Job: TH - Walled Garden Buildings

Title: Window Details - WTRF3 P2
Rooflight Type - RF2
Sheet 1 of 1

Type: Building 16 & 16a

Status: FOR PLANNING

03 Window Type RF3 - Double Glazed Roof Vent Wall Abutment Detail
751.1b SCALE 1:2 @ A1

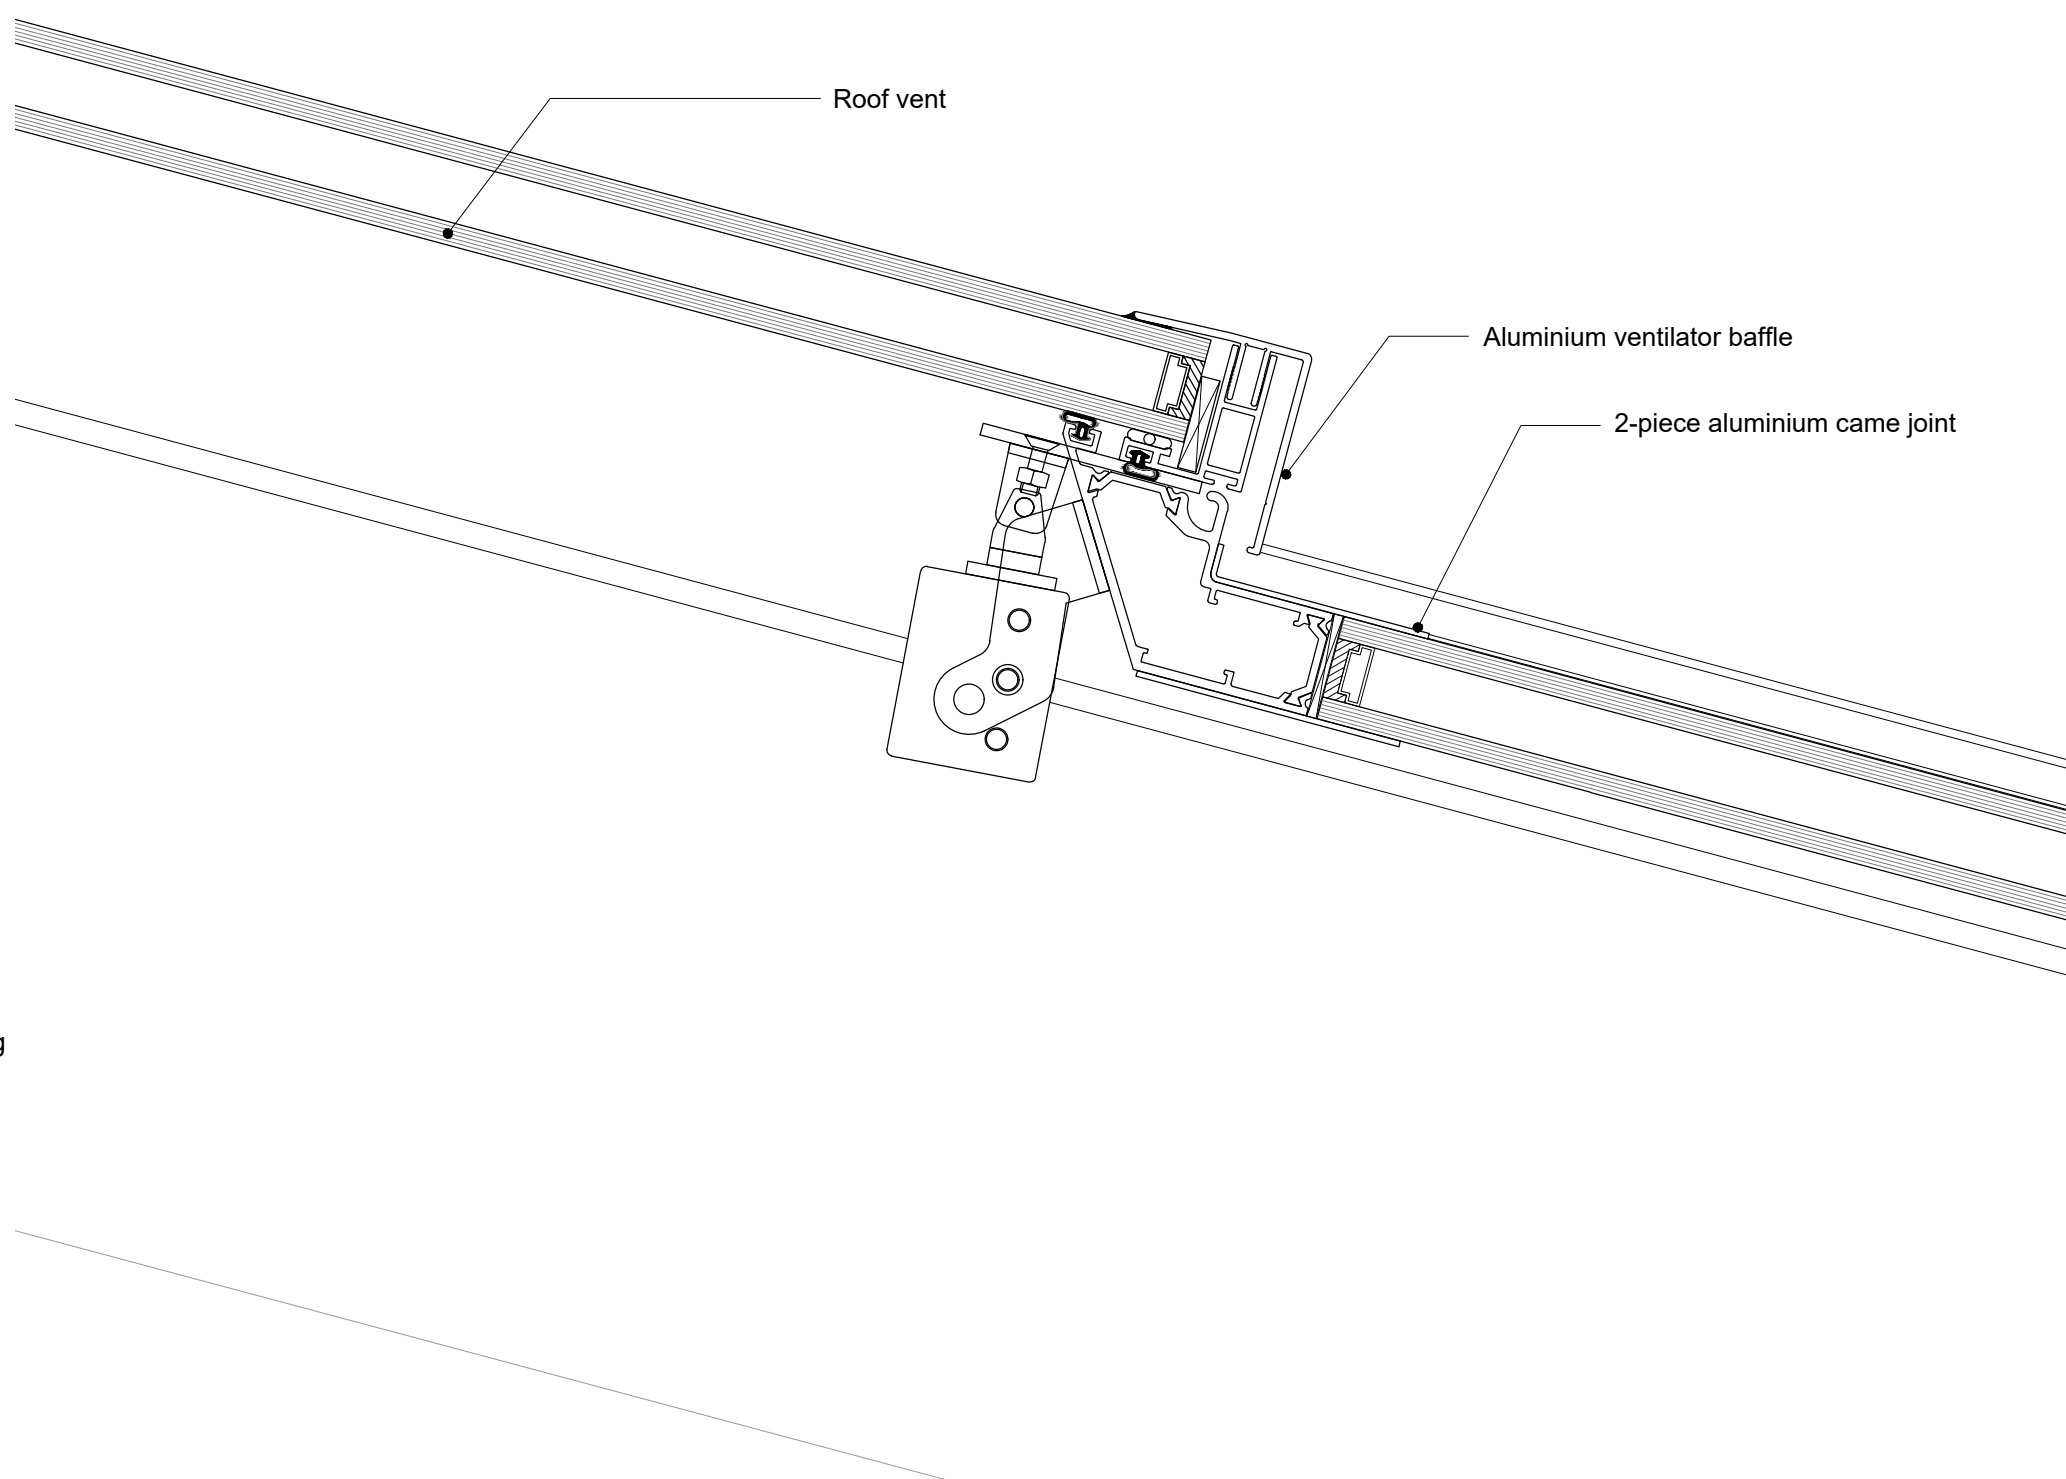
P2 Scale Bar Amended. Detail 3 updated with rear panel raised to roofline. Drawing number changed 27/03/26
